Architect's Supplemental Instructions

Architect's ASI No: 018

Project:
Webster University
Interdisciplinary Science
Building

Date Issued: 08/19/2016

S0303

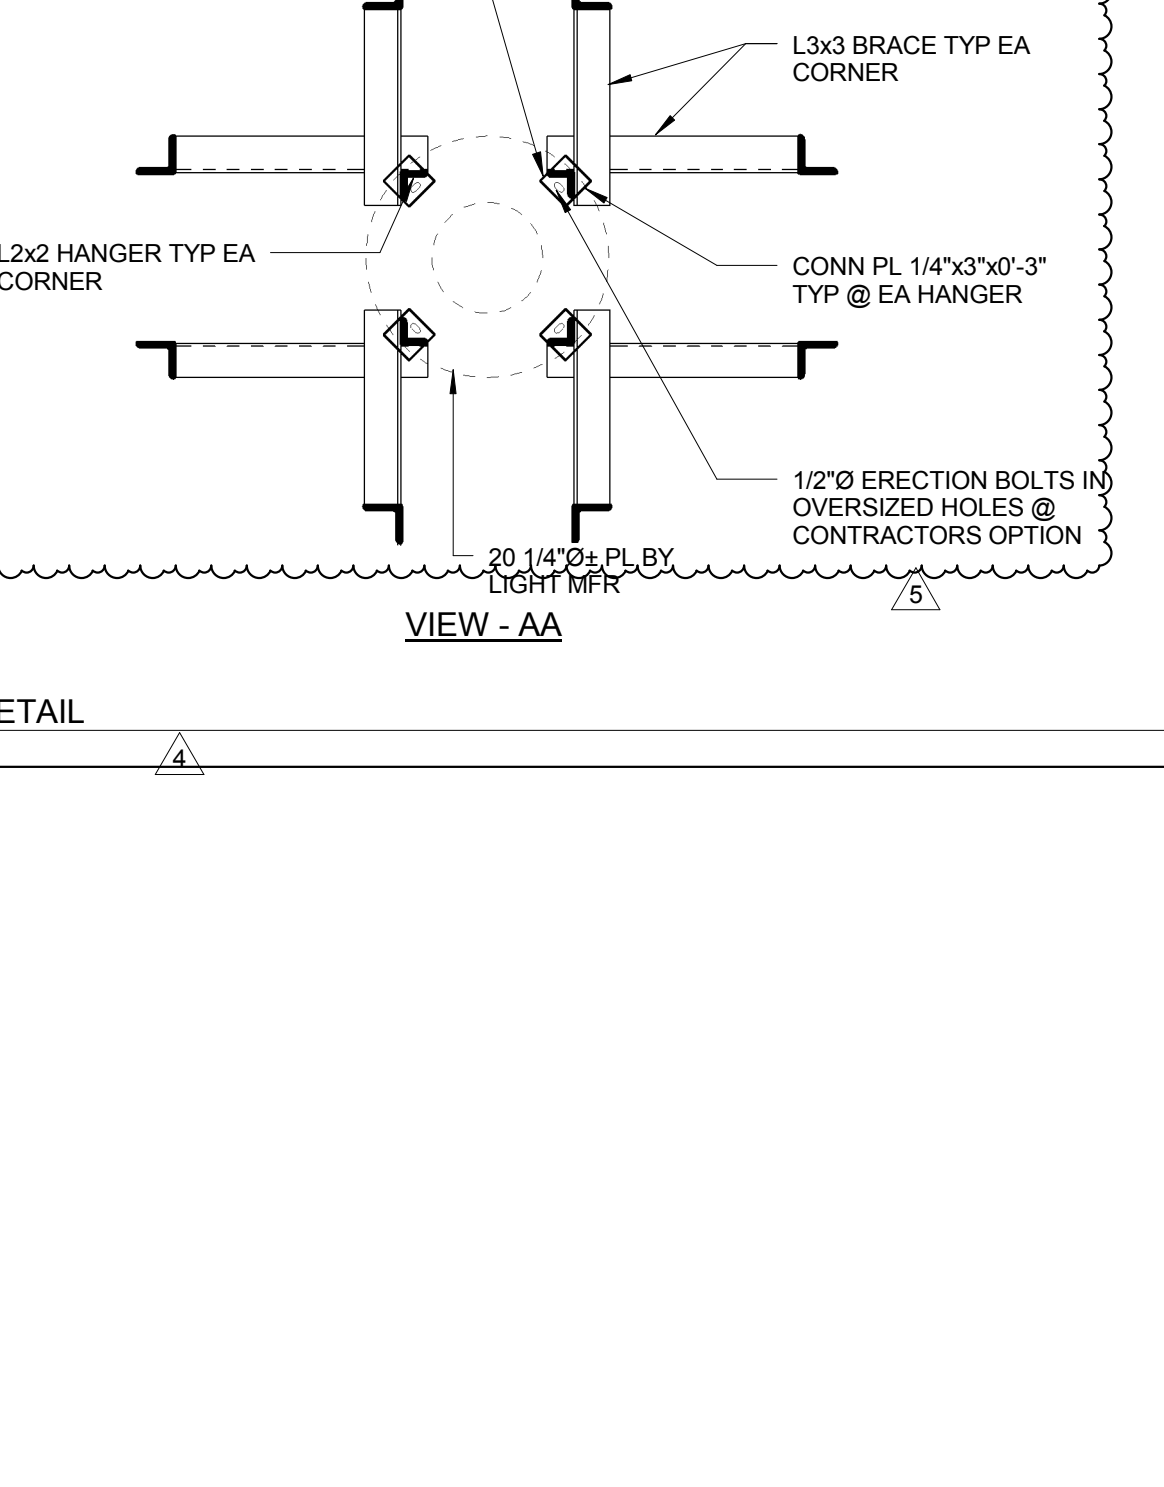
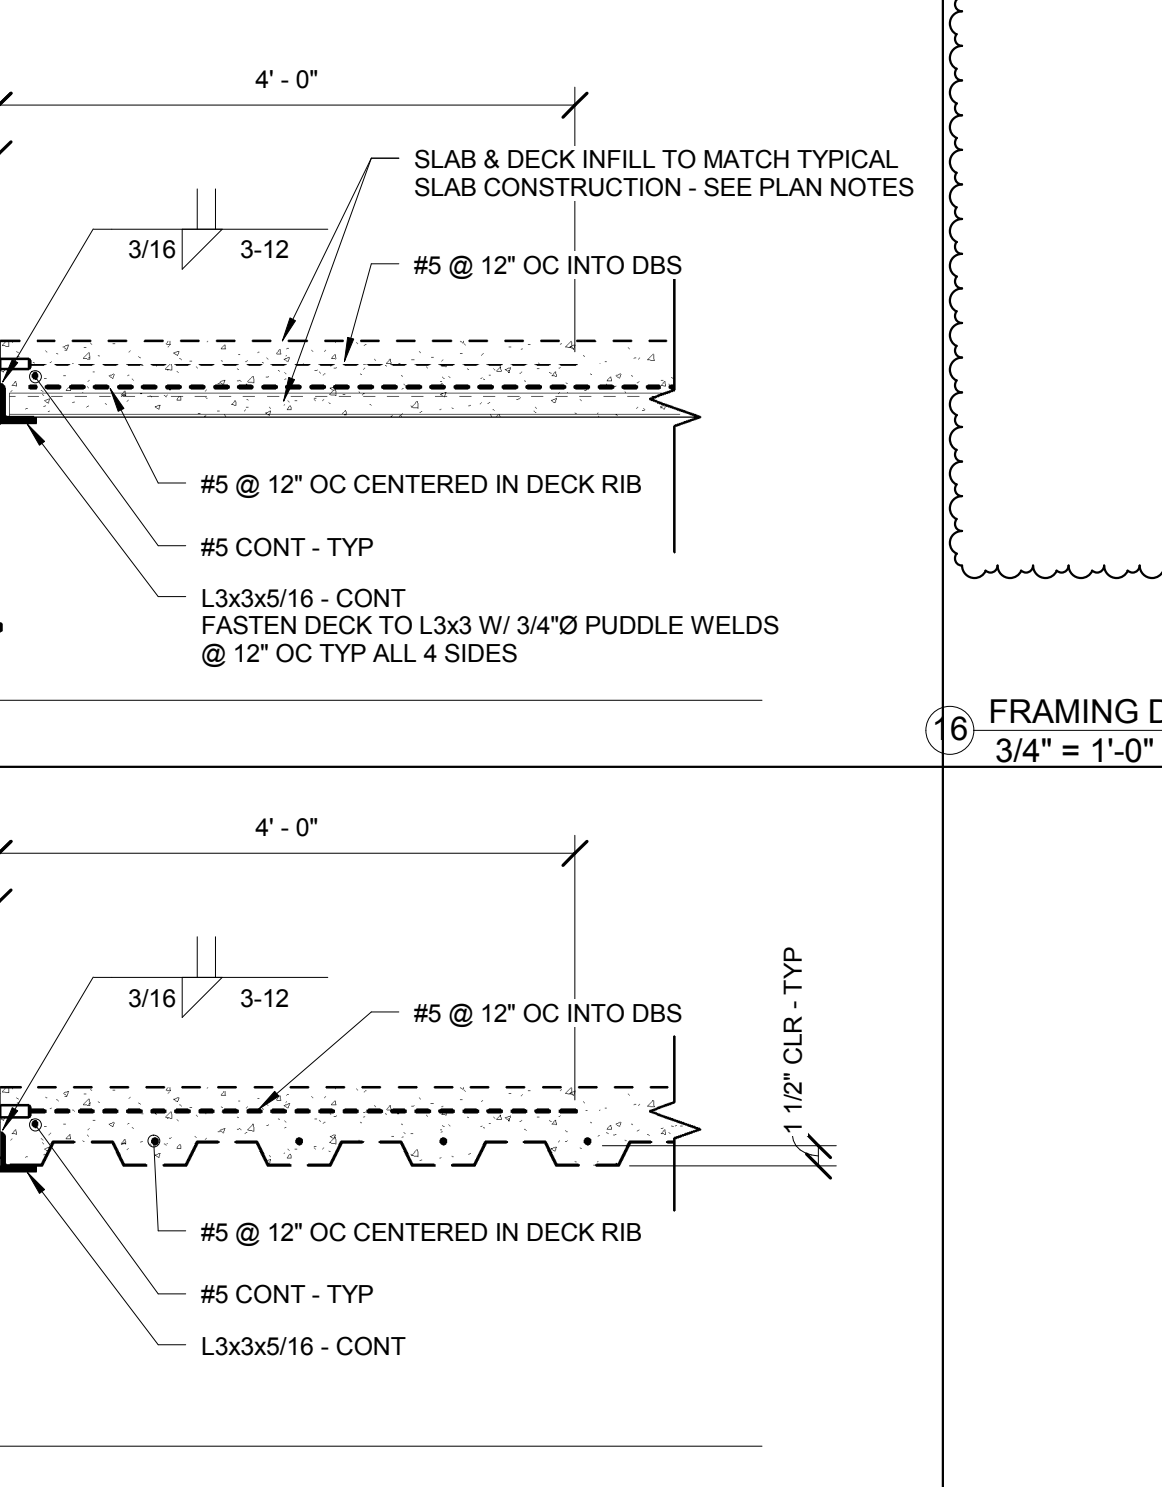
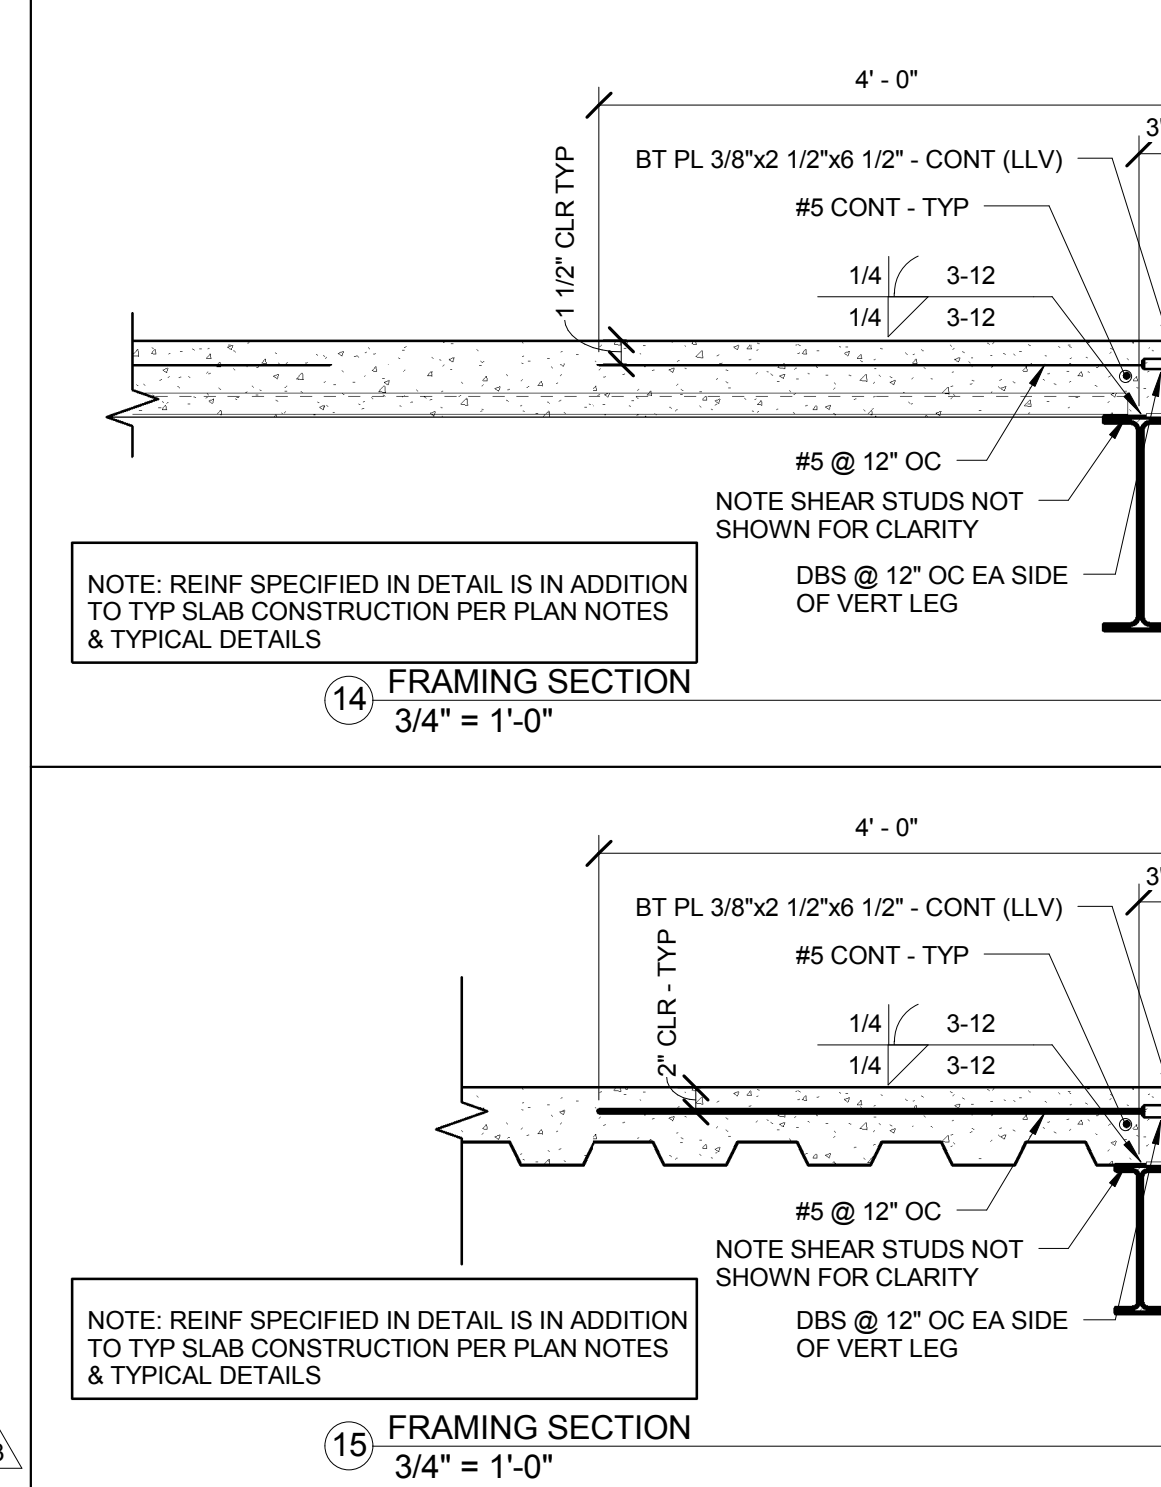
S0304:

Revisions to Detail number 16.
